SUBJECT: Transmittal of Responses to AP1000 DSER Open Items

Draft Safety Evaluation Report Open Item Response

In RAI 251.005, the staff requested that the applicant provide values of crack morphology parameters, e.g., surface roughness, number of 45 degree and 90 degree turns, etc., that were used in generating the BACs for LBB. The NRC staff also asked for a comparative study, using the values of crack morphology parameters associated with transgranular stress corrosion cracking (TGSCC). This information and the study were requested to evaluate the BACs and to understand the sensitivity of the AP1000 LBB analyses to a crack morphology similar to PWSCC. In its response to RAI 251.005, the applicant provided the values of crack morphology parameters used in generating the BACs. However, since chlorides will be controlled at minimum levels in the AP1000 LBB candidate piping systems water environment and the hydrogen overpressure will keep the oxygen levels to near zero, the applicant discounted the possibility of TGSCC and considered the comparative study using the crack morphology parameters associated with TGSCC not necessary. The applicant's argument does not address the intent

Figure 9 – Isometric View: Comparison of AP600 and AP1000 DVI-A Piping System

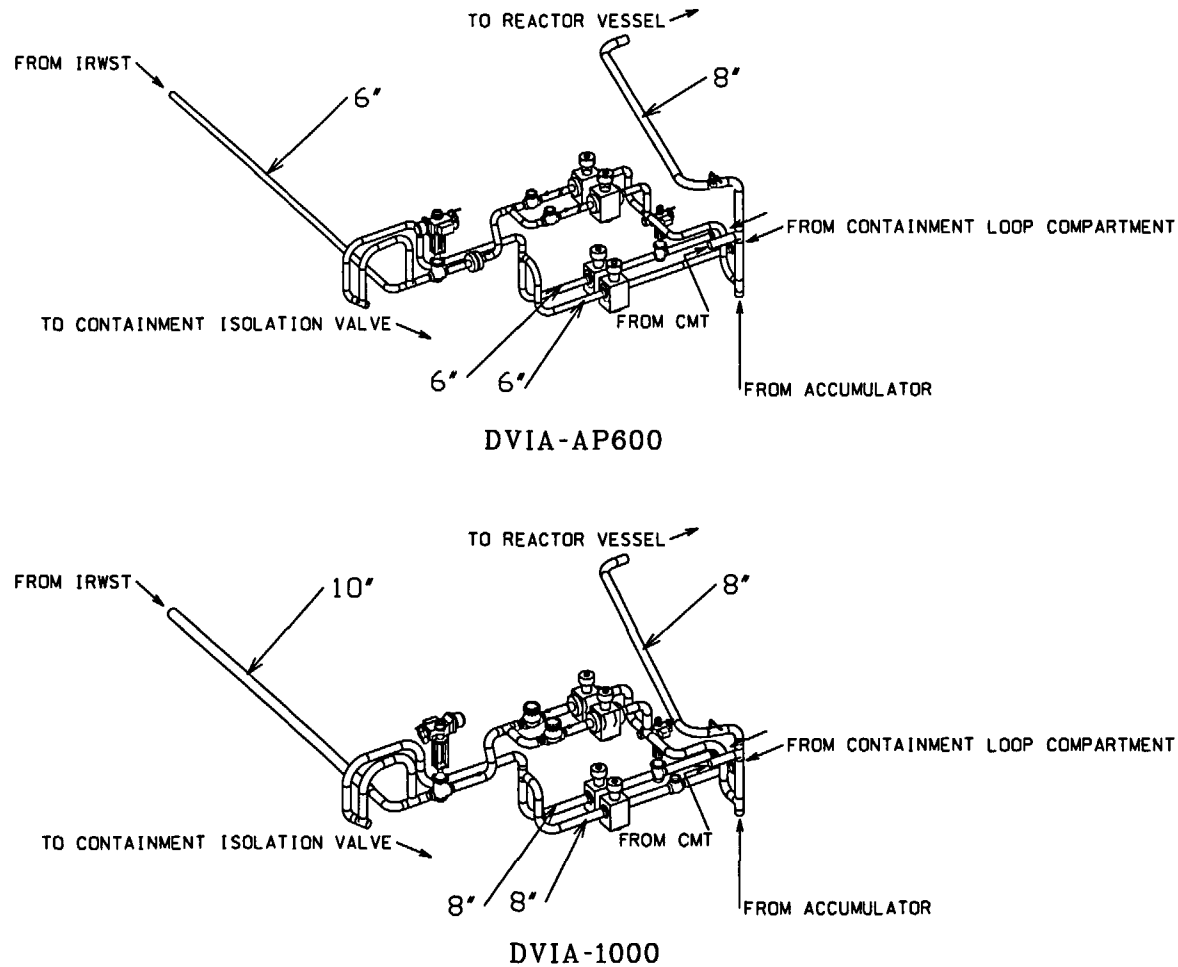
Complexity of piping system - The DVI-A piping system is complex, and was particularly challenging to qualify for the AP600. The AP600 design and analysis of the DVI-A subsystem was performed over several iterations that included perturbations in the piping layout, support configuration, and piping analysis. Figure 9 shows isometric views of both the AP600 and AP1000 DVI-A piping system.

Low Margin to BAC for AP600 - The AP600 analysis results for the DVI-A line exhibited low margin to the AP600 BAC limits. In addition, the limit for one particular line segment actually exceeded the BAC. (For that segment, engineering judgement was used to determine that modification of the final support configuration would result in reducing the stress limits to below the BAC for that line segment). Therefore it is expected that the DVI-A would be one of the most difficult piping systems to qualify for LBB for the AP1000.

Figure 16 - Bounding Analysis Curve – Primary Loop Hot Leg – 31”

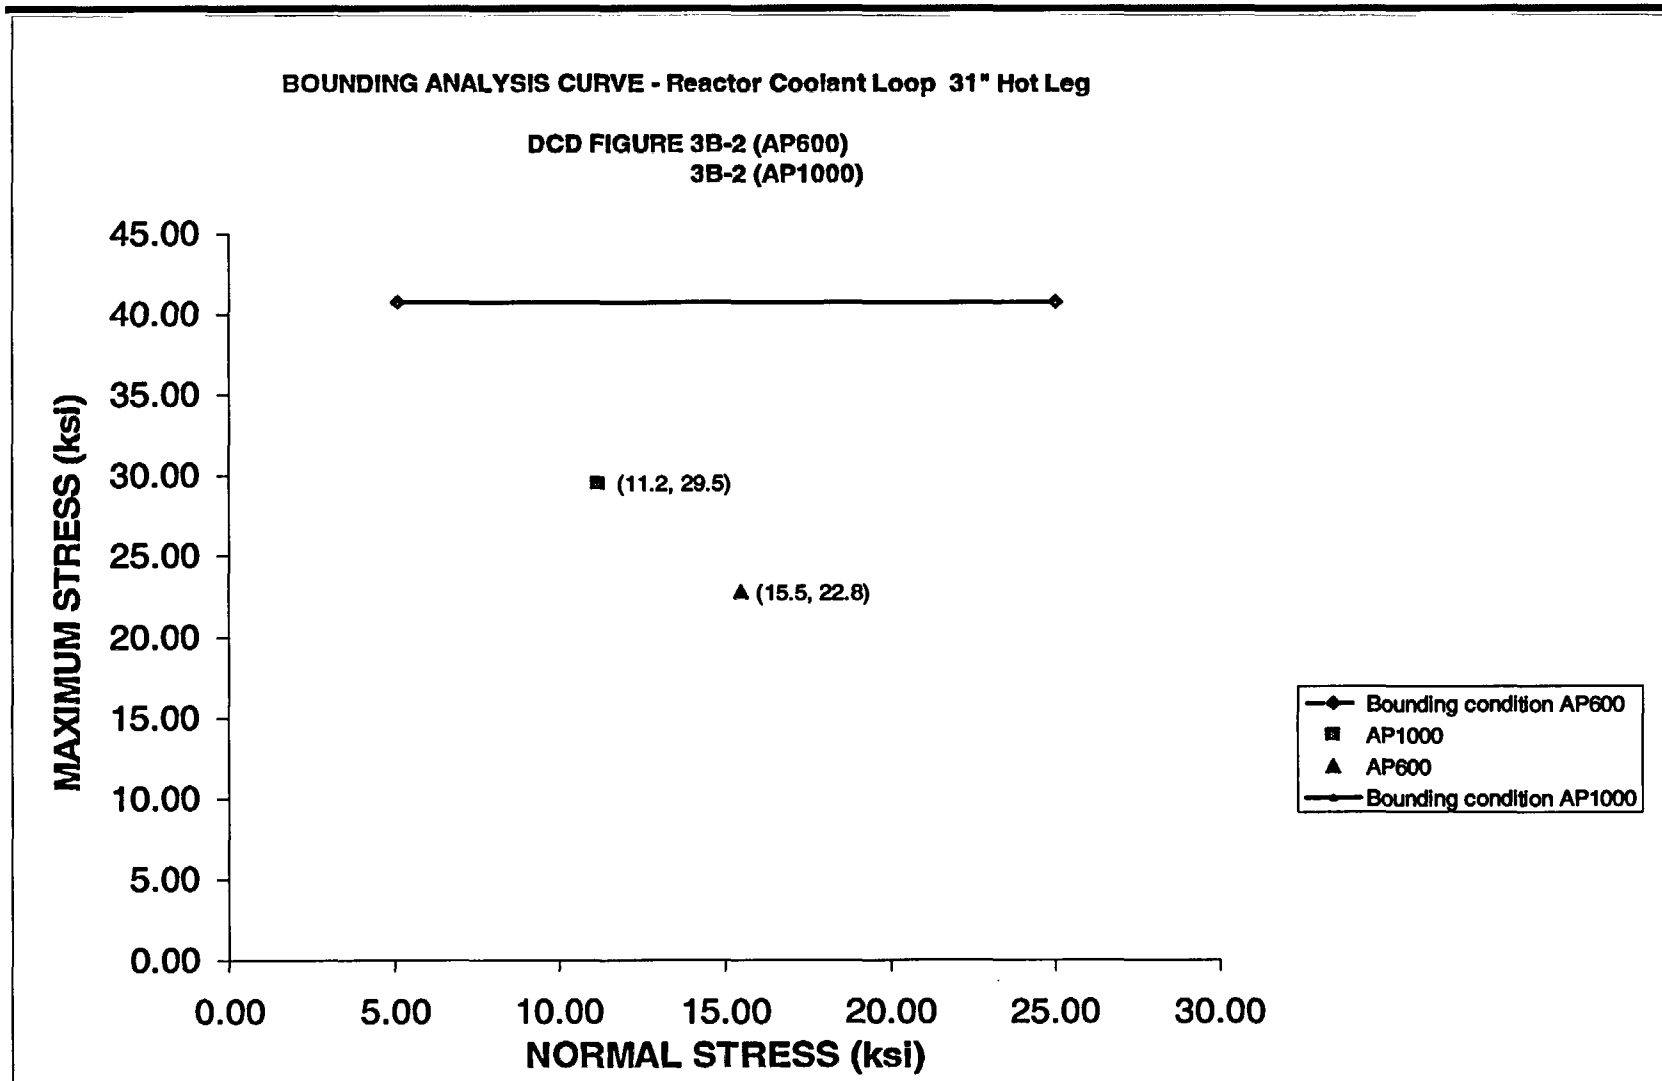
3.1 Primary Loop Hot Leg (31") – (Reference AP1000 DCD Figure 3B-2)

The Hot Leg pipe diameter is the same as AP600. The seismic multiplication factor is 1.74. This includes the affect of the higher elevation of the steam generator upper lateral support. The maximum stress is 29.5 ksi which is less than the BAC stress of 40.7 ksi. Figure 16 shows the BAC and the estimated stresses for the AP1000 plant. Feasibility of LBB for AP1000 is confirmed.

Figure 22 - Pressurizer Safety Valve Inlet Pipe Break Protection (Sheet 1 of 2)

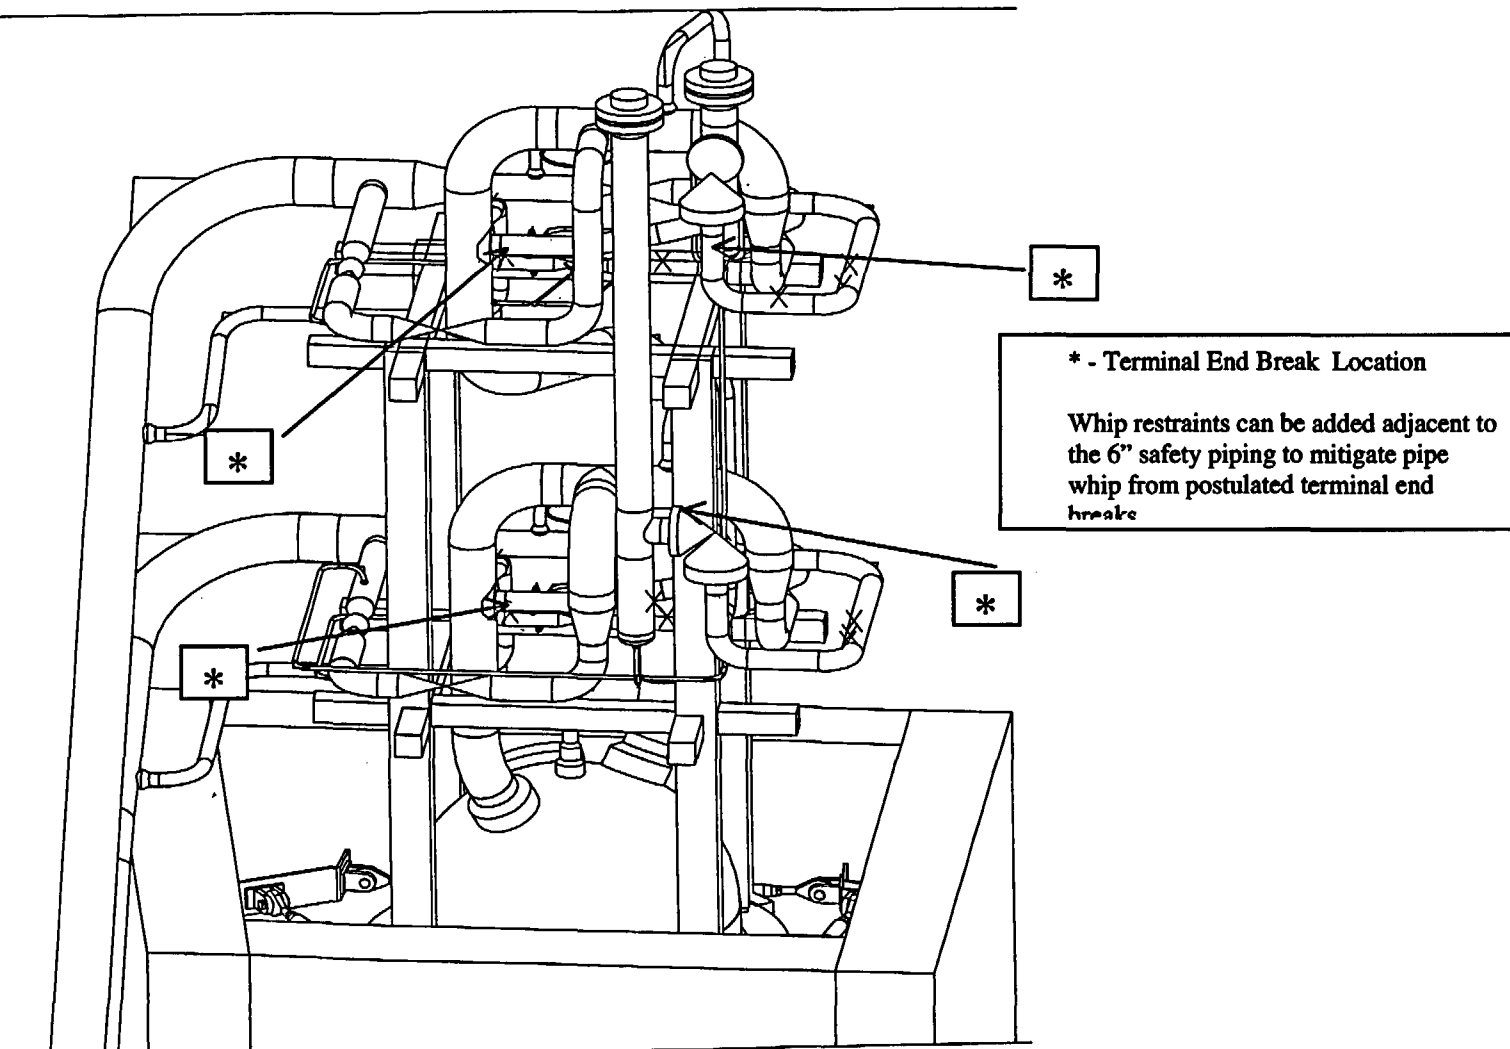
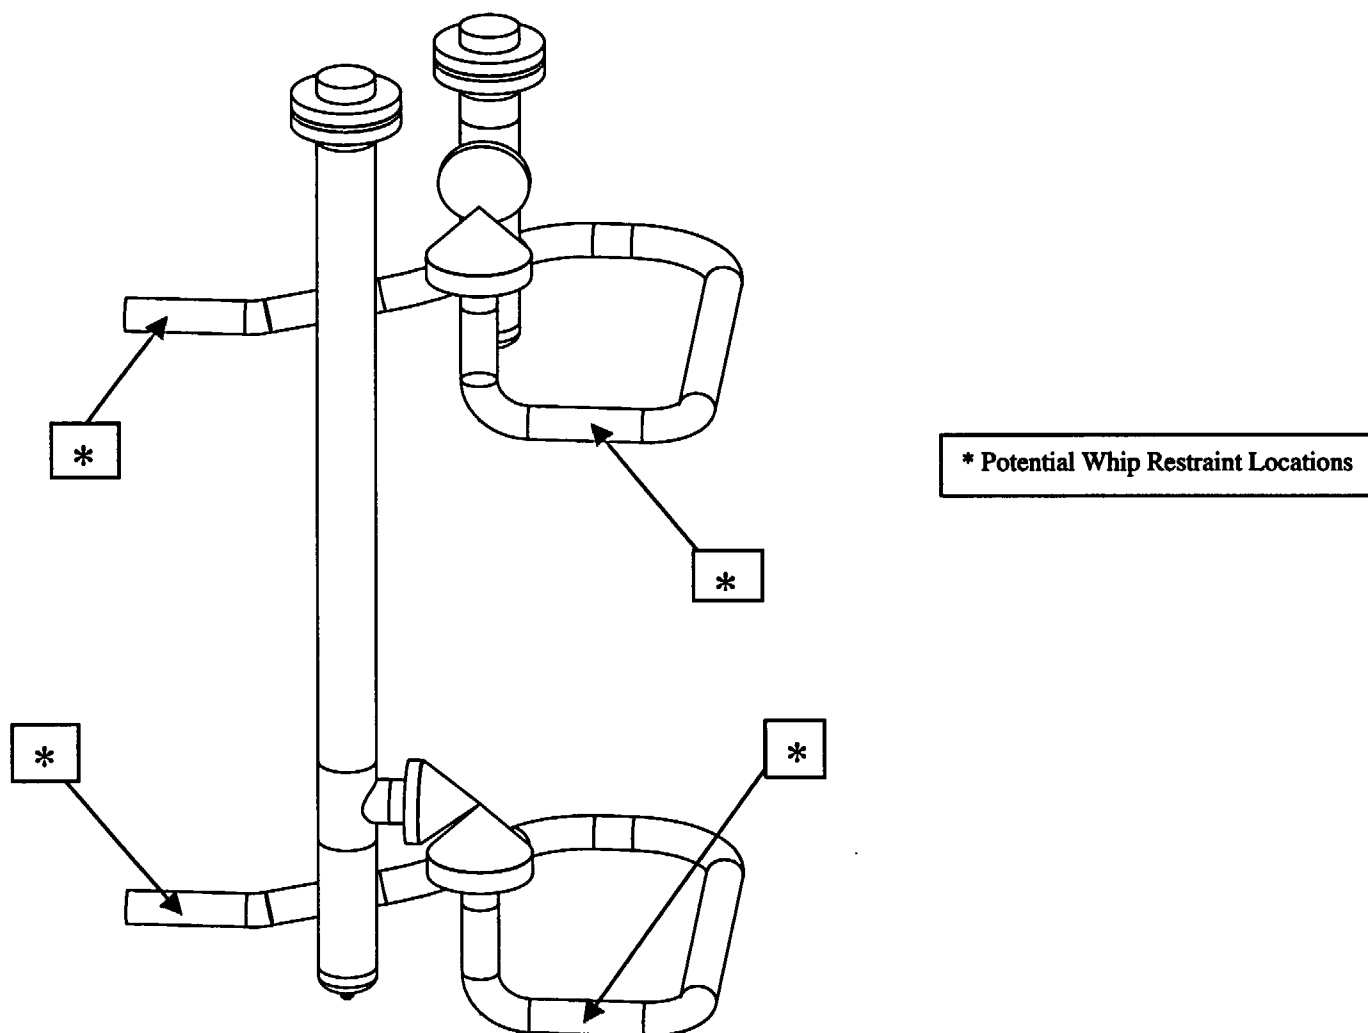
This report summarizes an assessment of applying Leak-Before-Break methodology to the candidate AP1000 plant pipe lines listed in Table 1. Feasibility is demonstrated for the LBB candidate piping systems with one possible exception of the Pressurizer Safety Valve inlet piping (6"). For these two lines, the high energy pipe breaks can be mitigated by the installation of protection devices (whip restraints) as shown at the locations in Figure 22 if required.

Figure 27 - Bounding Analysis Curve – Normal RHR Suction – 12"

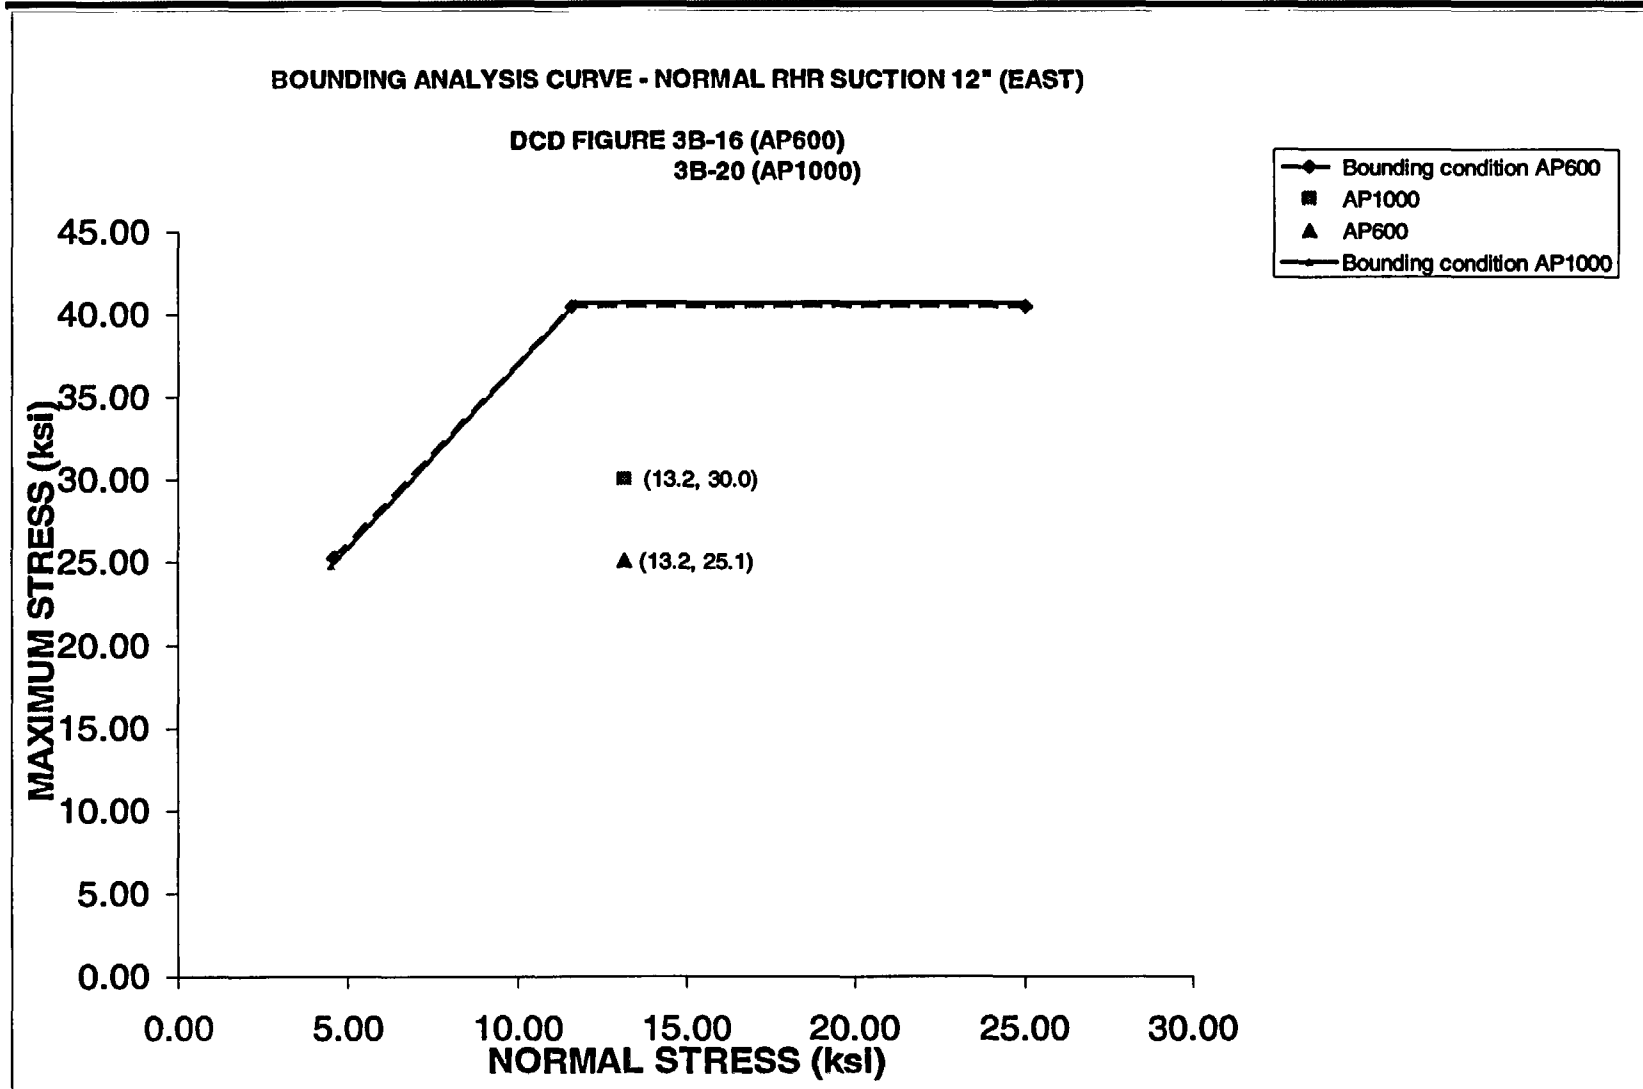
3.14 Normal RHR Suction (12") – (Reference AP1000 DCD Figure 3B-20)

support in the East subcompartment. The maximum stress is 30.0 ksi which is less than the BAC stress of 40.7 ksi. Figure 27 shows the BAC and the estimated stresses for the AP1000 plant. The feasibility of LBB for AP1000 is confirmed.

Figure 38 : Bounding Seismic Increase Factors -
Seismic Response Spectra, Steam Generator Support Elev. 135', (North-South) – 4th Stage ADS

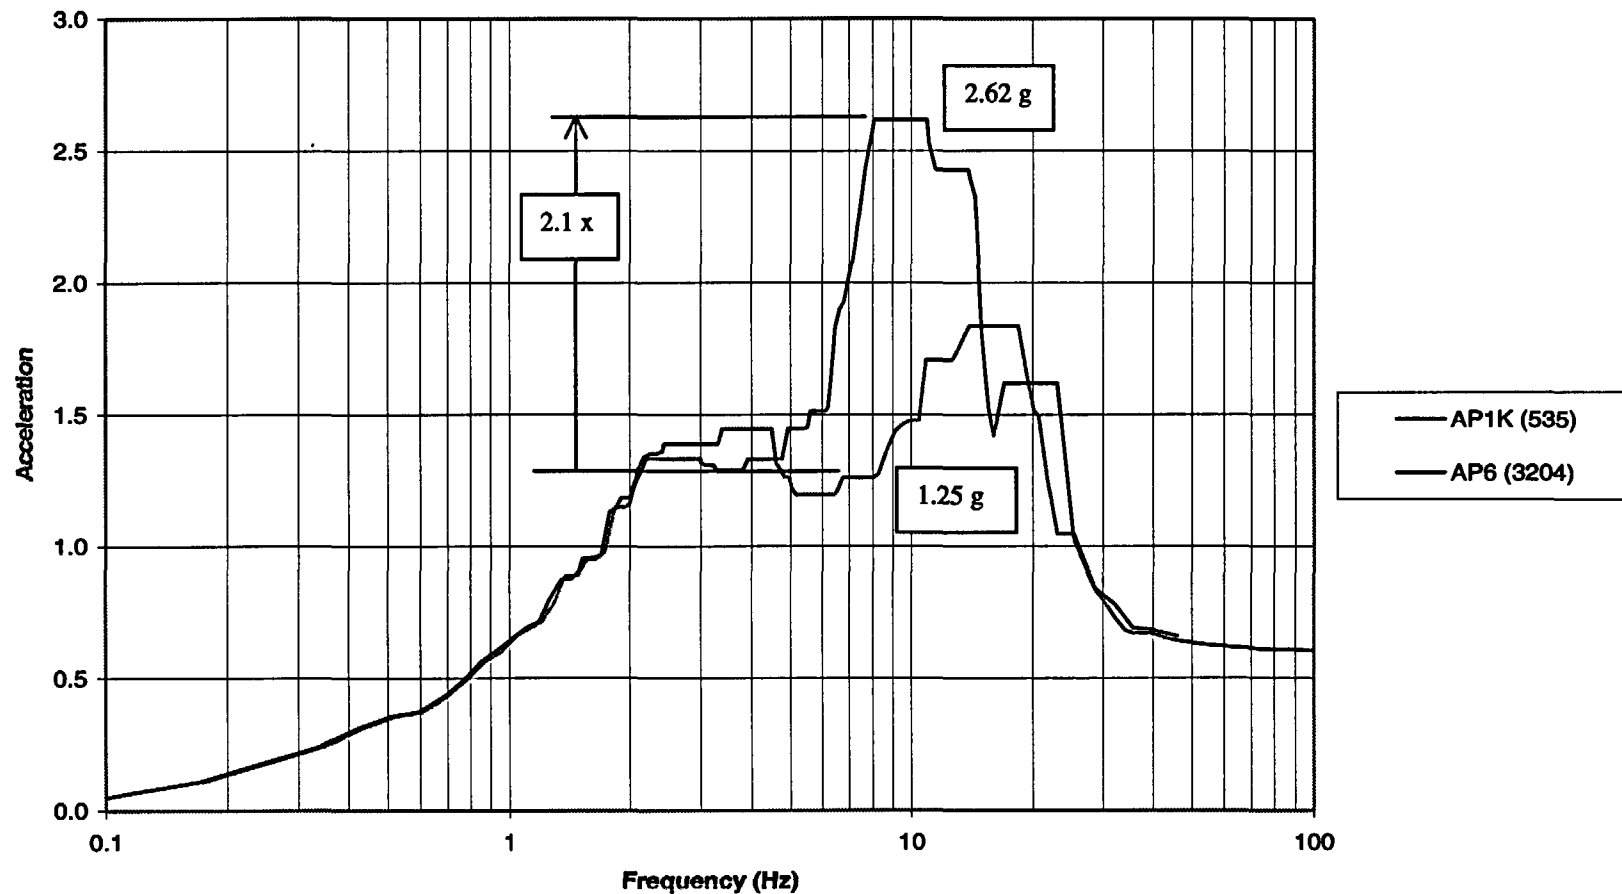
Due to the critical nature of this system, an additional assessment of the seismic loadings is performed to further demonstrate the feasibility of Leak-Before-Break for these lines. The applicable seismic response spectra are reviewed for the 4th stage ADS, East and West, and the maximum increase in response spectra acceleration identified based on individual frequency. This review results in the following seismic increase factors as shown in Figures 38 and 39:

The ADS Stage 4 pipe diameter is larger than the AP600 (12"). Per Figure 38, the seismic increase factor is 2.1 based on the seismic response spectra at approximately 8 Hz. The maximum stress is 33.0 ksi accounting for both the seismic increase factor and the increase in pipe diameter. The adjusted stress is less than the BAC stress of 40.7 ksi. Figure 40 shows the BAC and the estimated stresses for the AP1000 plant. Feasibility of LBB for AP1000 is confirmed.

The ADS Stage 4 pipe diameter is larger than the AP600 (10"). Per Figure 38, the seismic increase factor is 2.1 based on the seismic response spectra at approximately 8 Hz. The maximum stress is 38.0 ksi accounting for both the seismic increase factor and the increase in pipe diameter. The adjusted stress is less than the BAC stress of 40.7 ksi. Figure 41 shows the BAC and the estimated stresses for the AP1000 plant. Feasibility of LBB for AP1000 is confirmed.

The ADS Stage 4 pipe diameter is larger than the AP600 (10"). Per Figure 38, the seismic increase factor is 2.1 based on the seismic response spectra at approximately 8 Hz. The maximum stress is 36.5 ksi accounting for both the seismic increase factor and the increase in pipe diameter. The adjusted stress is less than the BAC stress of 51.9 ksi. Figure 42 shows the BAC and the estimated stresses for the AP1000 plant. Feasibility of LBB for AP1000 is confirmed.
